## **Addendum Number Three**

Date of Issue: 03/12/15

**Project:** USC South Tower Bathroom Renovations

Project Number: H27-6108-MJ

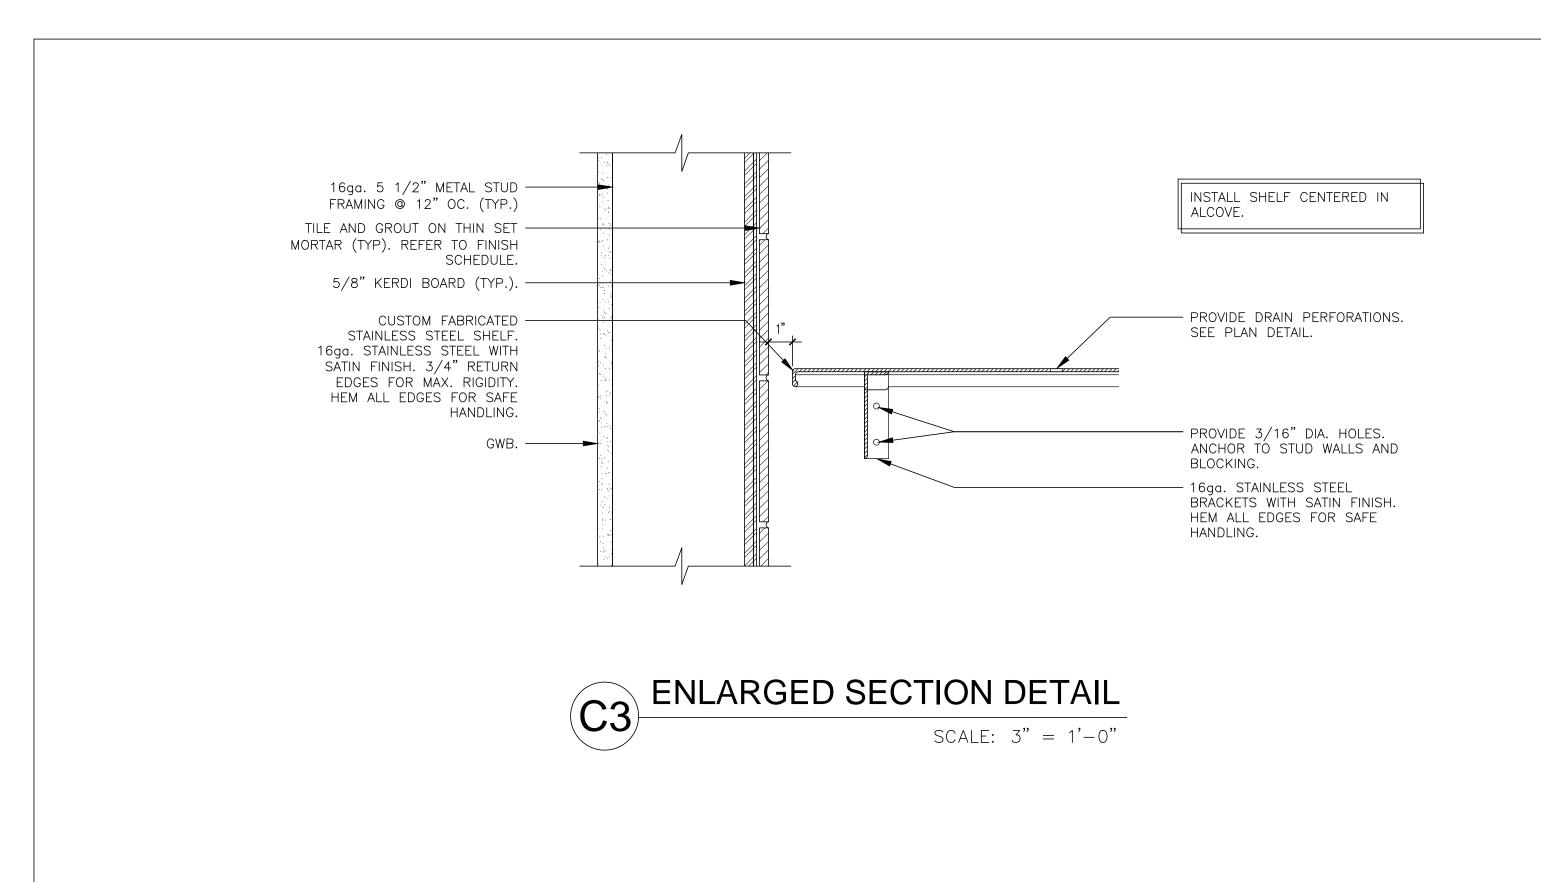
- 1. SHEET A502.1 Detail A3 Enlarged Plan Detail Revise the shelf dimension from ' 15" ' to ' 12" '.
- 2. SHEET A503.1 Delete DETAIL C3 and replace with the attached SK-A-003 dated 3/12/2015.
- 3. SHEET A503.1 Delete DETAIL C4 and replace with the attached SK-A-004 dated 3/12/2015.
- 4. SHEET P100 Revision: Reference Drawing P100, Renovation Floor Plans. On drawings 3/P100 and 7/P100 in Bathroom 105 and Bathroom 105A change the previously noted 'P-8 ADA' lavatory to a 'P-4 ADA' lavatory.
- 5. **SHEET P200** Revision: Reference Drawing P200, Details, Notes, Schedule, and Legend. See sketch SK-P-001. This sketch changes the model number on the P-4 fixture and indicates that the P-8 fixture is no longer used in the 'Plumbing Fixture Schedule'.
